Memo

To:	Mark Iszard and Carmel O'Sullivan (Healthy Waters)	Job No:	1008200.2000
From:	Tim Fisher and Charlotte Peyroux (Tonkin + Taylor)	Date:	6 April 2020
cc:	Andrew McCarthy (Oyster), Nick Roberts (Barkers)		
Subject:	Drury East (Oyster Capital) flood modelling - Response to Auckland Council Further Information Request on Stormwater Matters (Version 2)

Figure 2.1 - Northern sub-catchment 'development only' hydrographs

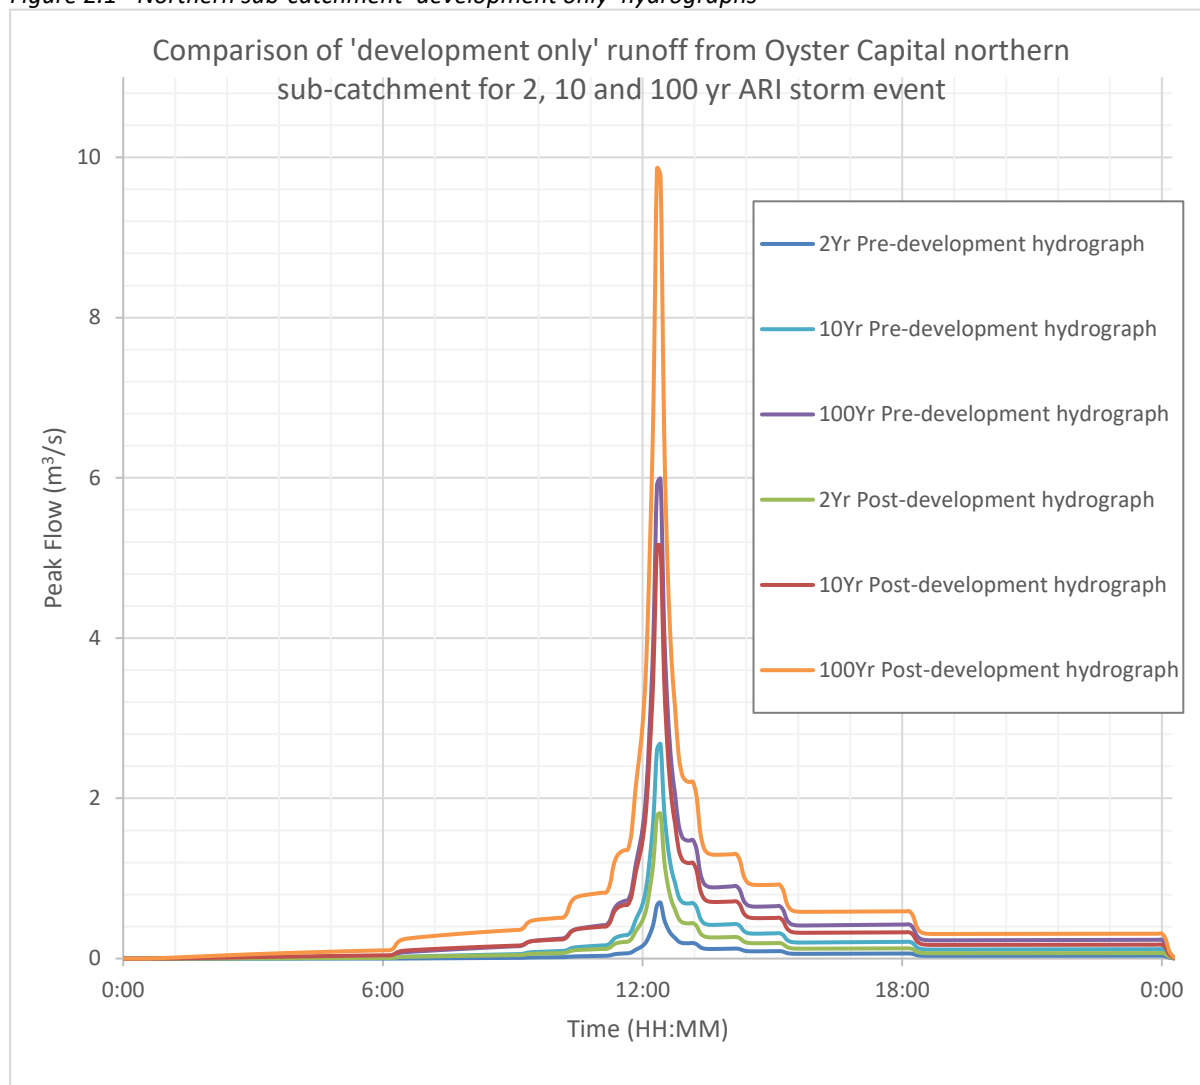
05	Flooding	<p>Please address the matters identified and discussed in the memo to Healthy Waters from Tonkin + Taylor dated 19 February 2020.</p> <p>We note that all applicants need to explain what the effect cumulatively across developments will be on the Drury township flooding and parts of the catchment that interact with the Slippery Creek floodplain.</p>	<p>Flooding in the Hingaia catchment is complex and needs to be considered in conjunction with other plan changes proposed for the area; acknowledge any interactions with other catchments and the cumulative impact of potential development in the surrounding areas and the point of discharge downstream. Understanding the impact of development on the flood plain within the plan change sites and impacts downstream is necessary to evaluate the plan change proposal and ensure any potential flood effects are avoided or mitigated.</p>	Refer to Section 2 of this memo

Figure 2.1 shows the northern sub-catchment development only hydrographs generated in HEC HMS and Table 1 shows the peak flow rates for the pre- and post-development 2, 10 and 100 year ARI rainfall events.

The results show that in all design rainfall events the post-development flows are almost twice that of pre-development flows.
